# Technical BULLETIN

## EPA & CARB RECALL

### CERTAIN 2024-MODEL F2.5, F4, AND F6 OUTBOARD MOTORS FACTORY MODIFICATION CAMPAIGN – Emissions Control Information Label

F2.5B

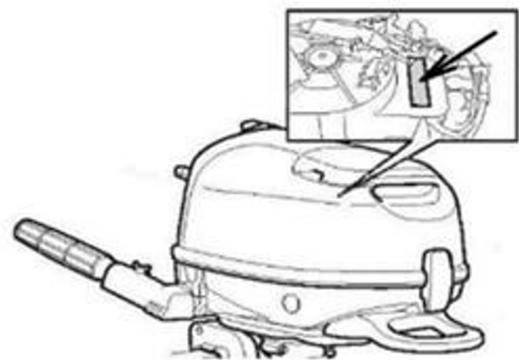
2. Inspect the ECI label on the engine according to the *Identification Procedure* in this bulletin. If it is incorrect, remove it.

**TIP:** It is easier to remove the label by using a heat gun (hold it approximately 12 inches away for 30 to 40 seconds). Wipe the surface clean with a degreaser and adhesive remover using a clean cloth. Be sure the area is clean and dry.

3. Affix the new ECI label in the same location as the previous label. Mark the area to the upper left of the label using a yellow paint pen to indicate completion of the modification (see *Identification Procedure* below for details).

Example: F4 Model

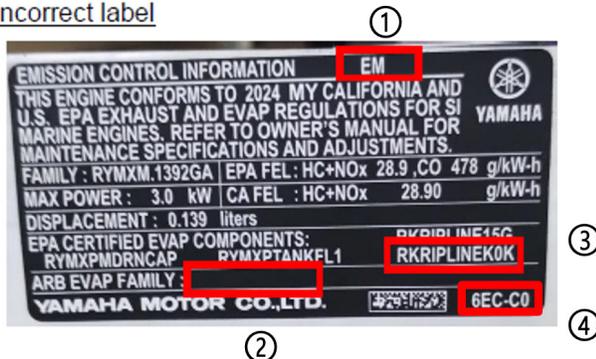
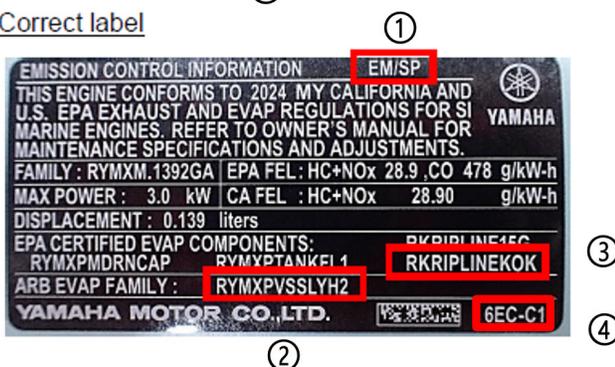
Identify if the label is incorrect using the ECI label contents and the presence of an identification mark (yellow paint mark).

Incorrect label

Correct label

Applicable Part	Model Name (Code)	Incorrect Label	Correct Label
① EMISSION CONTROL TECH	F2.5 (6EG)	EM	EM/CP
	F4 (6EC)	EM	EM/SP
	F6 (6EE)	EM	EM/SP
② ARB EVAP FAMILY	F2.5 (6EG)	Blank	RYMXPVSSLYH1
	F4 (6EC)	Blank	RYMXPVSSLYH2
	F6 (6EE)	Blank	RYMXPVSSLYH2
③ EPA CERTIFIED EVAP COMPONENTS	F2.5 (6EG)	Not applicable	
	F4 (6EC)	RKRRIPLINEK0K	RKRRIPLINEK0K
	F6 (6EE)	RKRRIPLINEK0K	RKRRIPLINEK0K
④ PART No.	F2.5 (6EG)	6EG-90	6EG-91
	F4 (6EC)	6EC-C0	6EC-C1
	F6 (6EE)	6EE-C0	6EE-C1

**F2.5B**

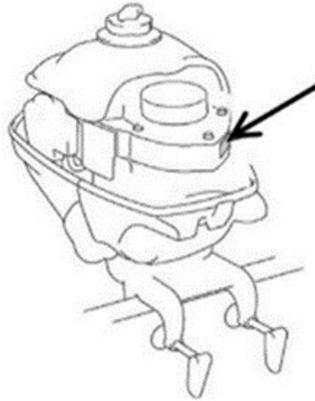
Identify by the yellow paint mark
